# IFSAR Quality Assessment Report

## Alaska Mid-Accuracy DEM Kenai

NGTOC  
2016-08-15  
Sheila Ruhl

**AK IFSAR Kenai AOI for FY2015**  
Approximately 50,323 sq km/19,430 sq mi (landmass of clipped cells)

Checkpoint Distribution Image

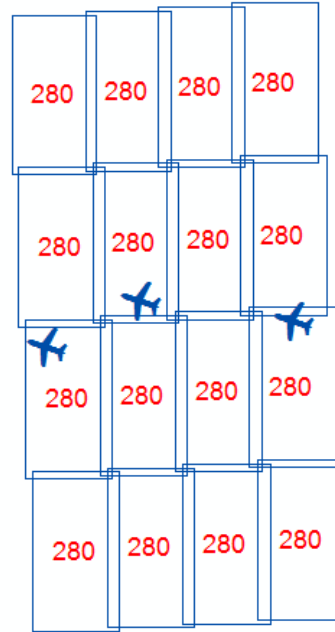
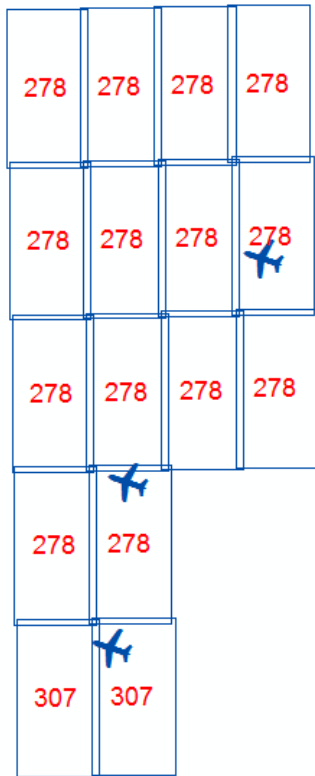
An independent survey was conducted by JOA Surveys, LLC. JOA Surveys acquired three **(3) total checkpoints** within Kenai Lot 2 **Cell 280**. Due to the limited number of checkpoints within a single cell, this cell was combined with the Kenai Lot 2 cells 278 and 307. A total of **(3) points** were used in cells **278 and 307**.

Dewberry buffered all potential checkpoints by the radial RMSE value of 8.035 meters. Only checkpoints whose entire buffered area were completely within the slope category of 0°-10° were used to calculate the vertical accuracy. **All six (6) checkpoints were located on terrain with a slope of 0°-10°** and were used to calculate vertical accuracy statistics for the Kenai Lot 2 Cell 280. No checkpoints

Based on this review, the USGS accepts the vertical accuracy.
